**Planned Unit Development – 14607 Chandler Road
- AD Industrial Park – Fenton Construction**

**Replat – 14607 Chandler Road - AD Industrial Park –
Fenton Construction**

**CITY OF LA VISTA
PLANNING DIVISION
RECOMMENDATION REPORT**

CASE NUMBERS: PPUD23-0005; PRP23-0005

PUD SITE PLAN

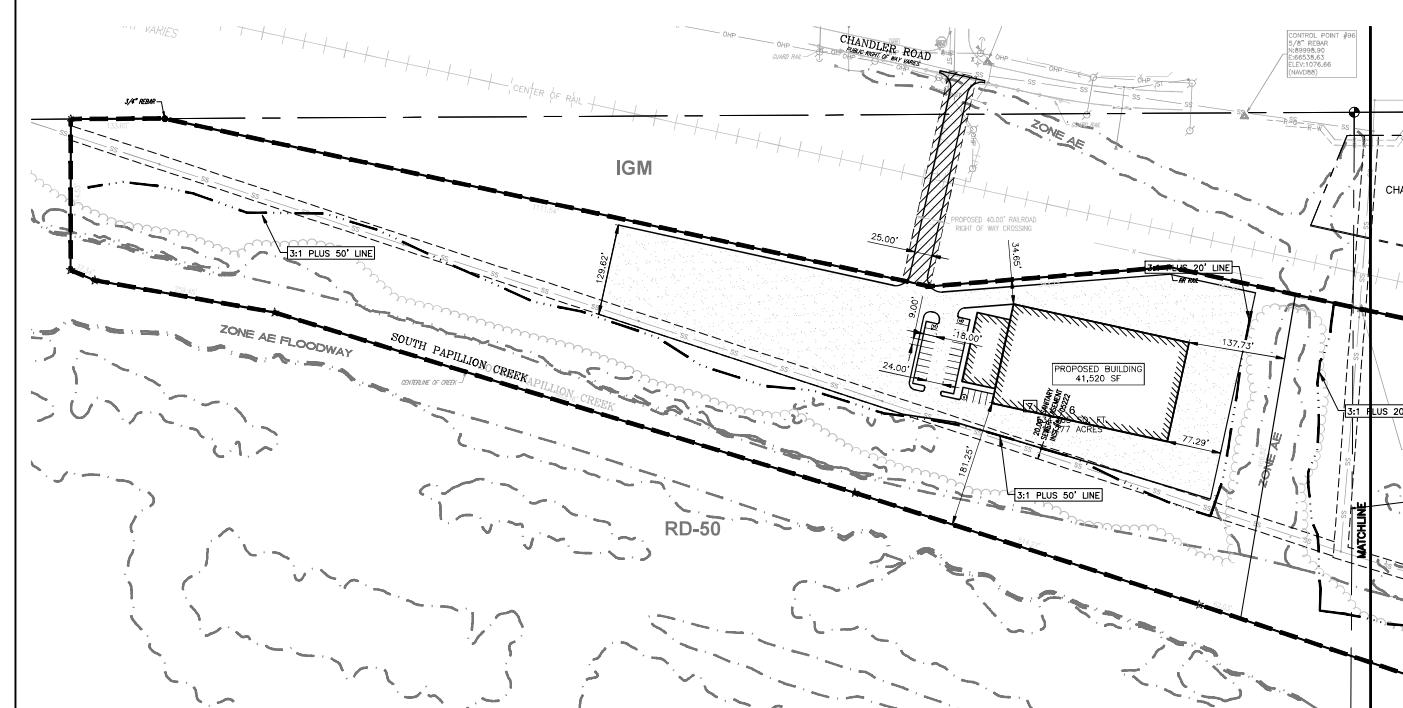
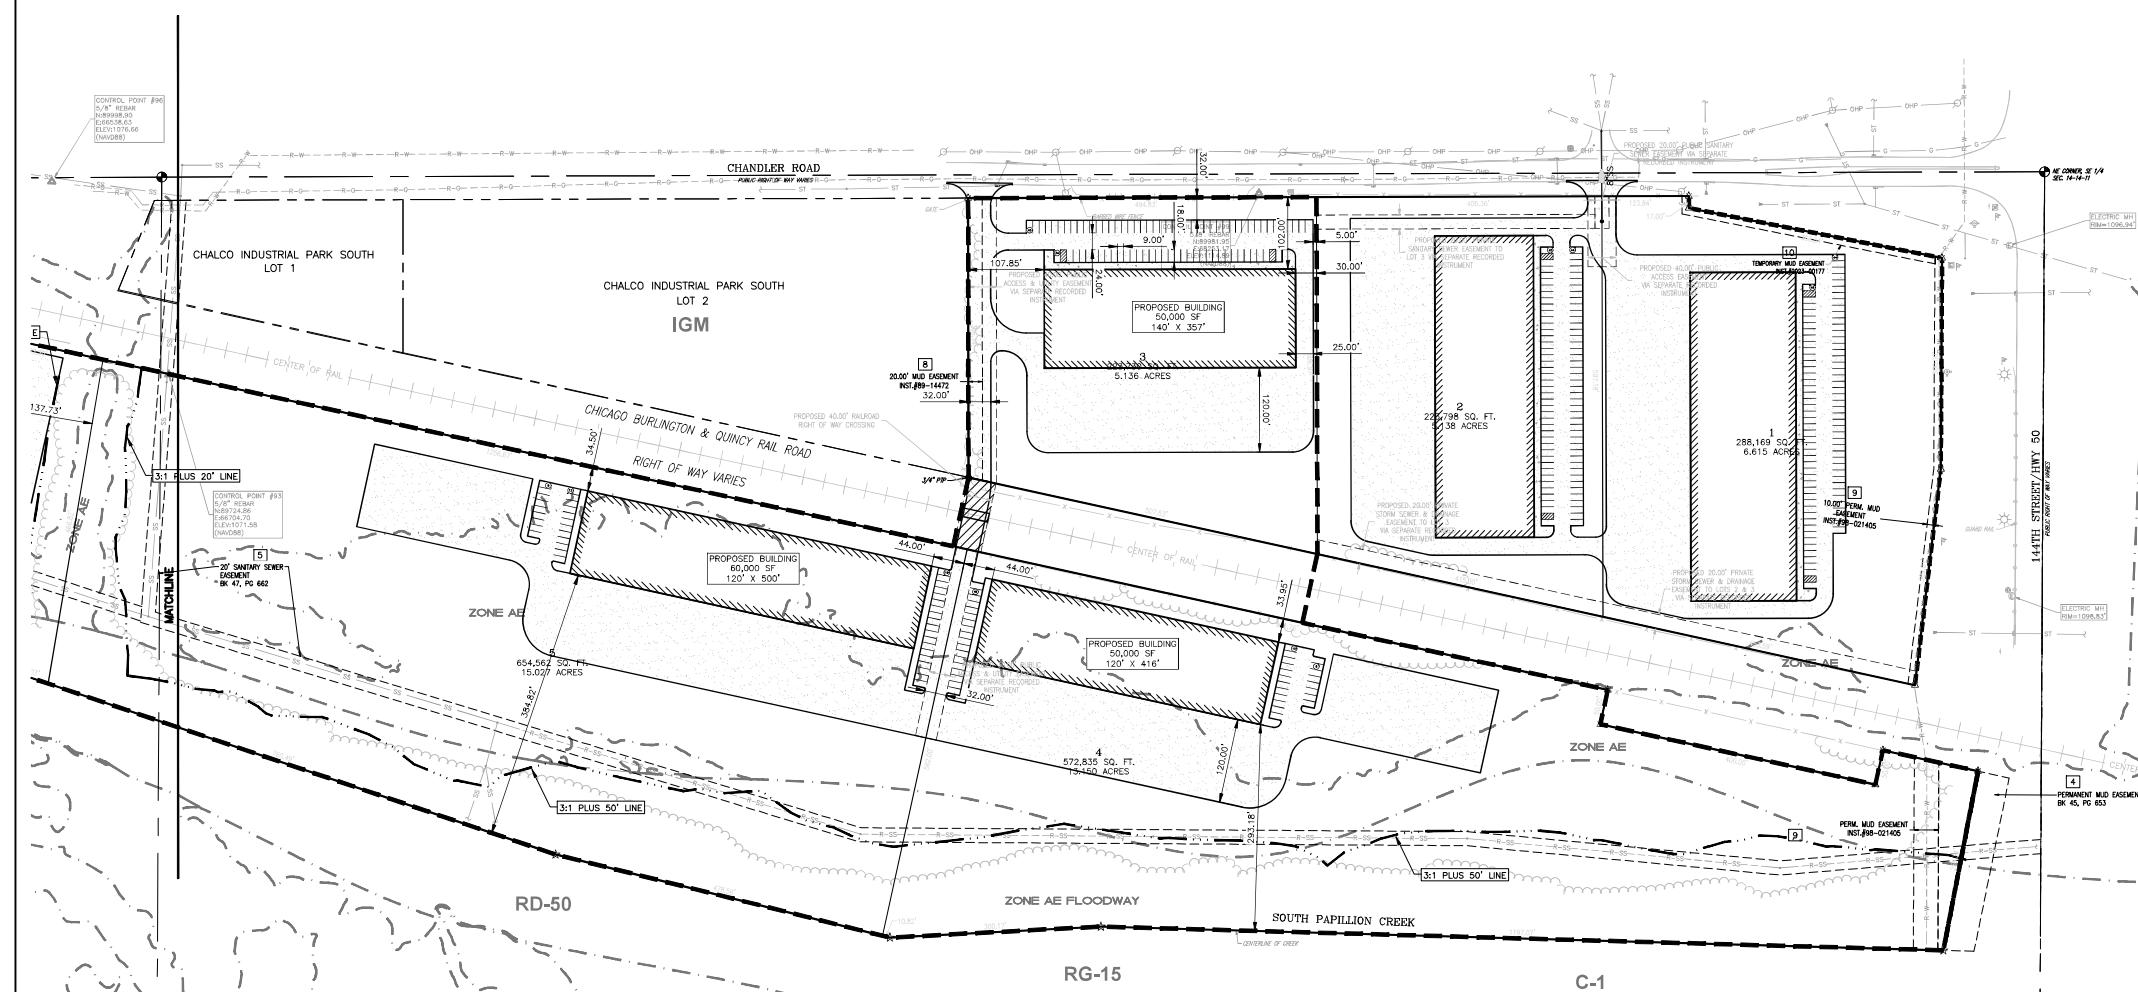
10. Regarding Section 5.15.05.02.2, please provide the height of all proposed structures.

4. The boundaries of the PUD Site Plans within the submittal package are not contiguous. The boundaries of the PUD Site Plan set should match that of the PUD district boundary set within the Zoning Map Amendment approved by the City Council on November 21, 2023. Attached is an excerpt from the City Council packet that depicts the PUD district boundary as contiguous, crossing over the railroad along the eastern edge of Lot 2 in the submitted plan set.

Response: All structures are anticipated to have a height of 40'. The table on the PUD site plan has been updated.

Response: PUD limit has been redrawn to be continuous located along the eastern edge of Lot 3 projected across the Railroad ROW. The owner does not desire to include Lot 2 in the PUD.

PUD LANDSCAPE PLAN

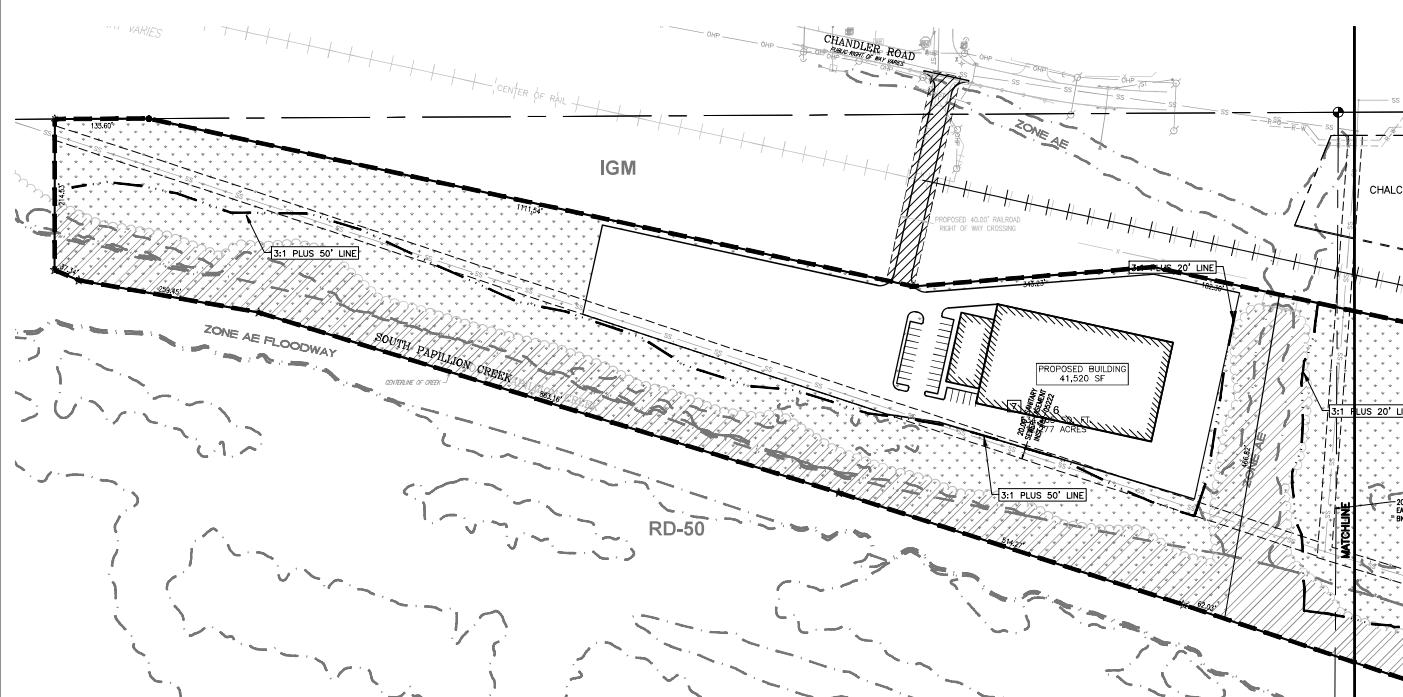
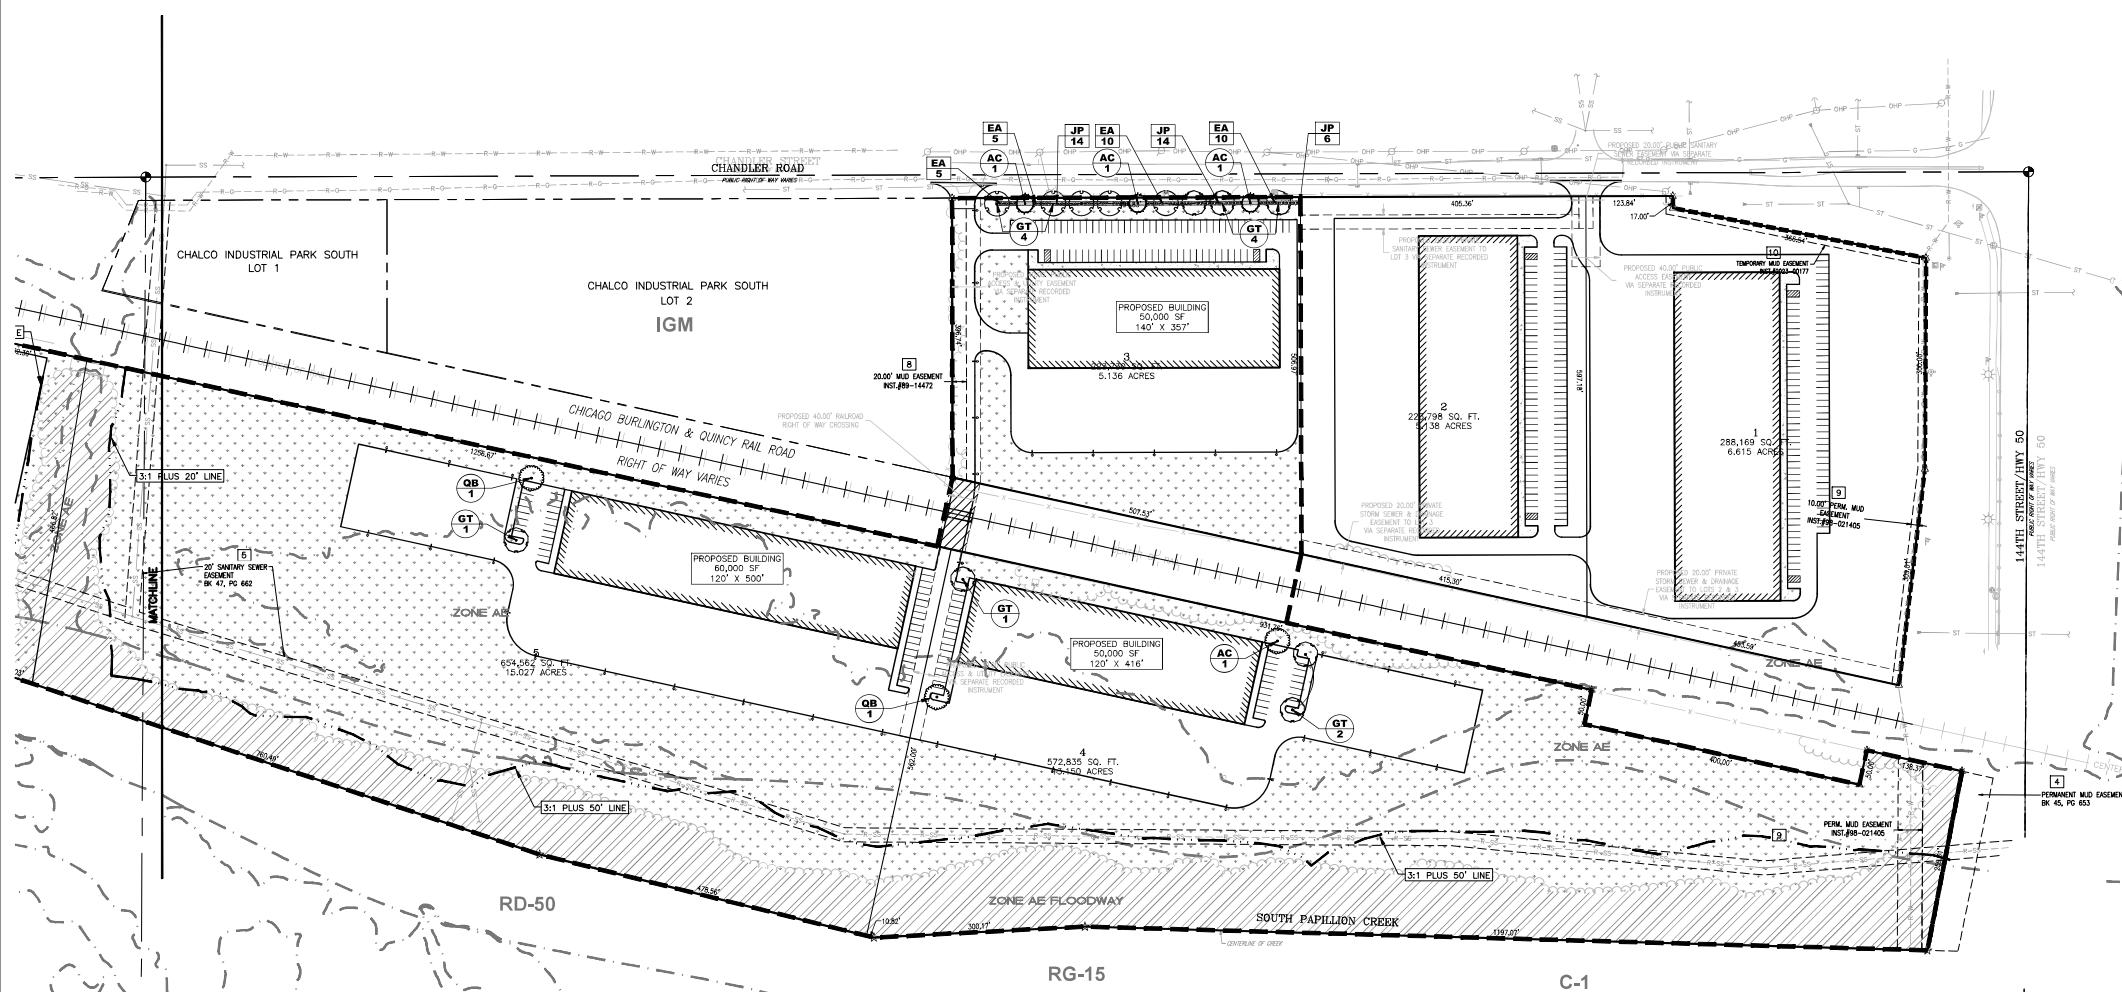
17. Please add parking lot light pole locations to the landscaping plan of the PUD plan set in order to ensure there are no conflicts with the plating plan as presented.

2. Per 4.III.F, Landscape plan shall be designed to provide natural undulating landscape forms and avoid straight line plantings. All proposed plantings are arranged as straight line plantings.

Response: Parking lot light pole locations have been added to the landscaping plan. A mix of Pole mount lighting and building mount downlighting will be utilized for all buildings.

Response: The landscape plan for Lot 1 will be modified to provide natural undulating landscape forms and avoid straight line plantings when submitted for design review at the time of end user lot development. The area of plantings in Lot 3 along Chandler Road are outside the limits of the Corridor Overlay District. For clarity, all plantings outside the limits of the PUD area have been removed from the Landscape plan.
